CK-578 D

THE TECHNICAL MATERIEL CORP.		MAMARONECK, NEW YORK	
TITLE			
DIAGRAM, SCHEMATIC			
MAIN CHASSIS			
DRAWN	DATE	FINAL APPROVAL	DATE
Checked	7/2/62		
MECH. DES.		DATE	
8-6-62		8-6-62	
SHEET		REV. LTR.	
1		E

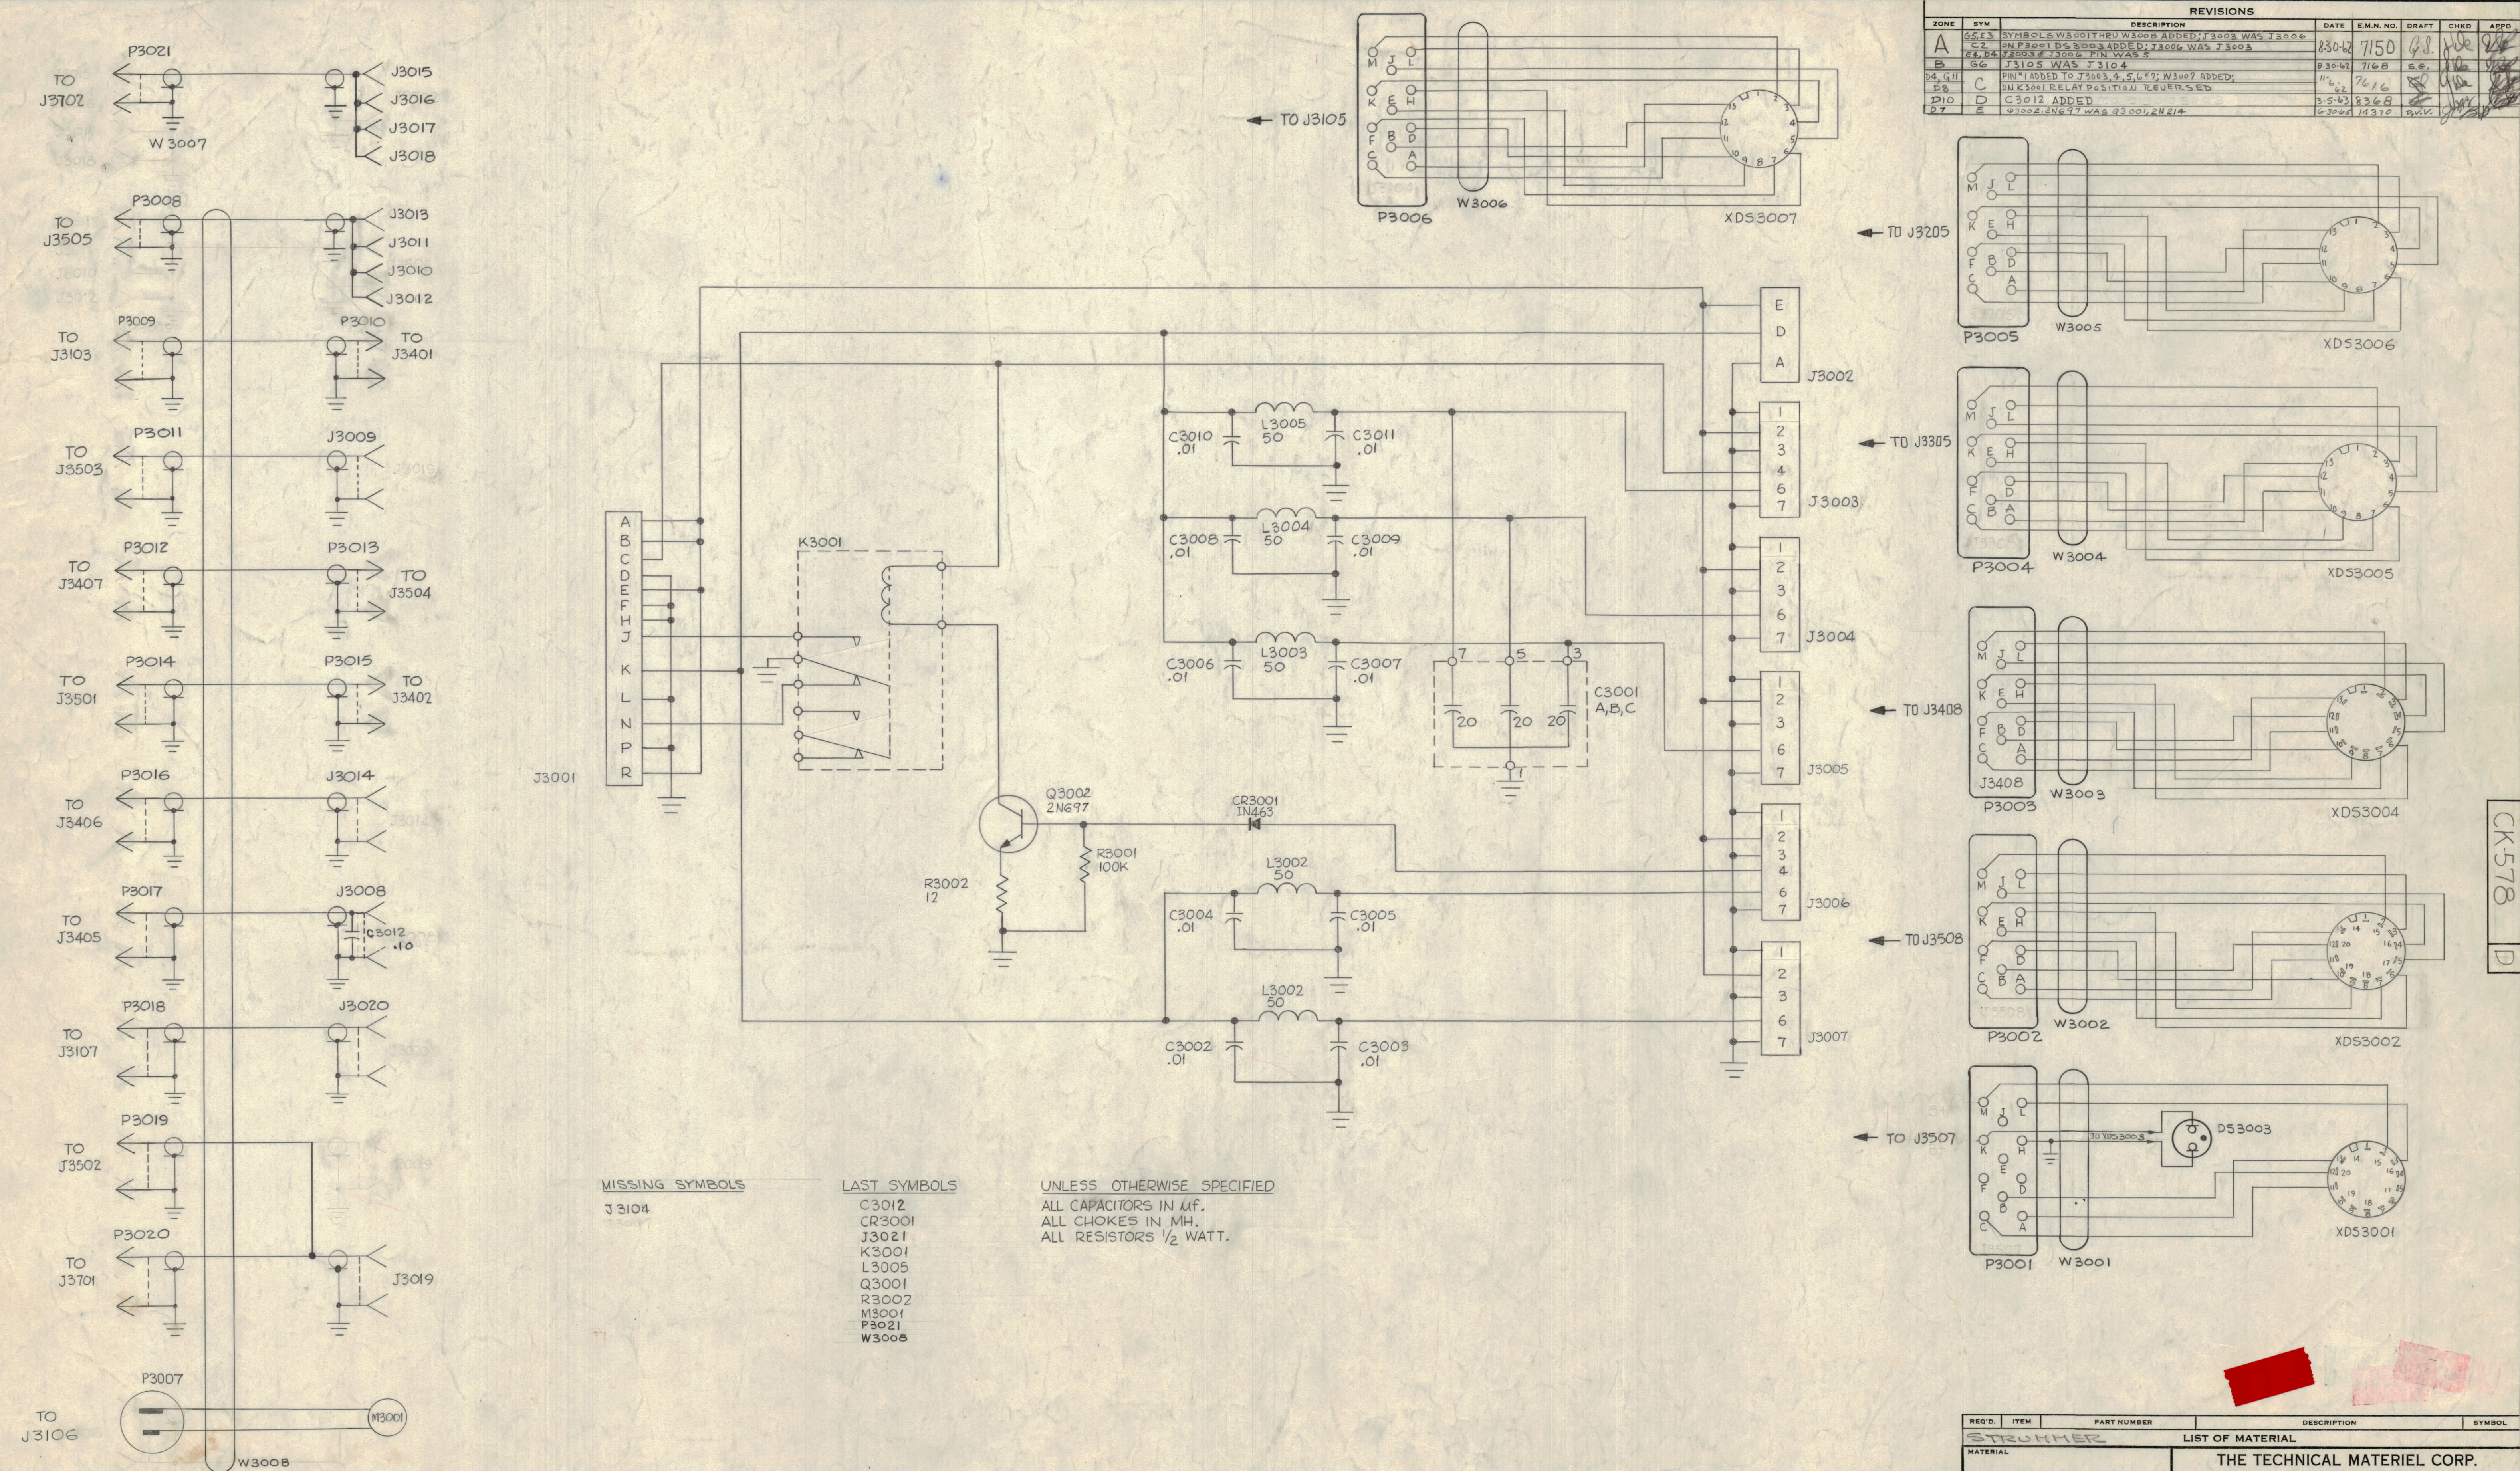
REVISIONS						
ZONE	SYM	DESCRIPTION	DATE	E.M.N. NO.	DRAFT	CHKD
A	65, E3	SYMBOLS W3001 THRU W3008 ADDED; J3003 WAS J3006	8-30-62	7150		
	C2	ON P3001 DS 3003 ADDED; J3006 WAS J3003				
B	64, B4	J3003 & J3006 FINAL WAS 3	8-30-62	7168		
	B6	J3105 WAS J3104				
B4, G11	C	PIN#1 ADDED TO J3003, 4, 5, 6, 7; W3007 ADDED;	11-22-62	7616		
B8	D	ON K3001 RELAY POSITION REVERSED	3-5-63	8368		
D10	D	C3012 ADDED	6-30-63	14370		
D7	E	Q3002, ENG 47 WAS Q3001, 2N414
